Title: TOP			 life.augmented
Project: NUCLEO32			
Size: A4	Reference: MB1180	Revision: C.1	
Date: 6/5/2015		Sheet: 1 of 3

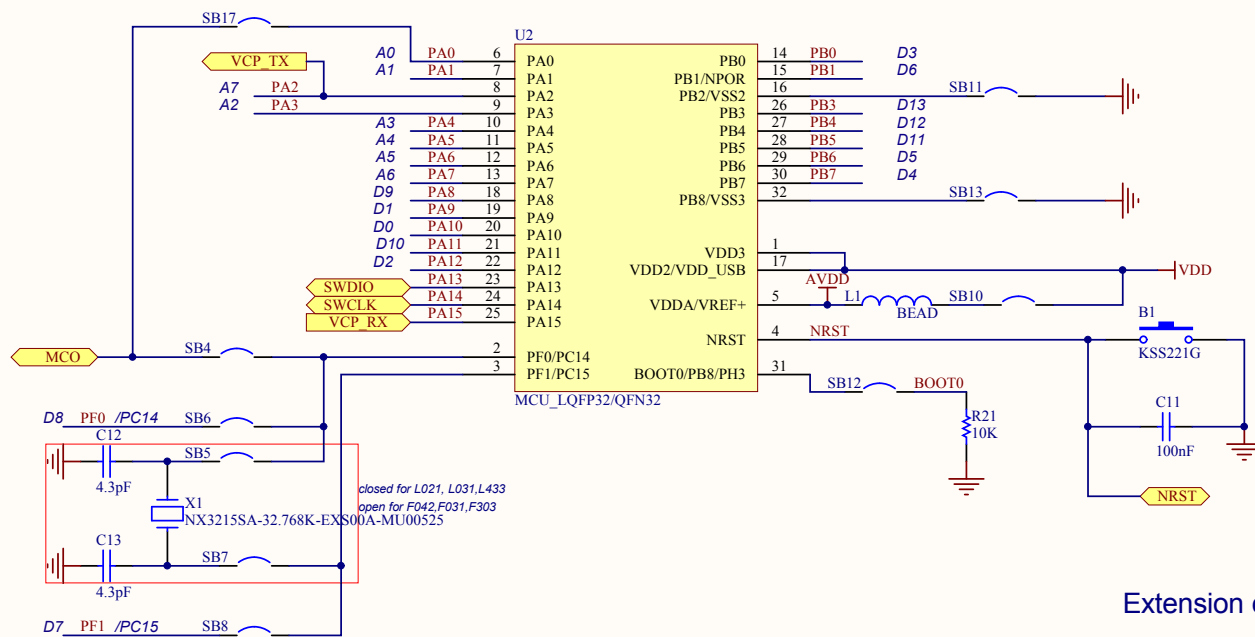
REV B: SB14 changed to JP1 Jumper for easy IDD measurement, and enlarge board length; CN1 USB PN changed to Micro-B for Device.
REV C: Add SB18/SB16 for connecting D4/D5 to A4/A5
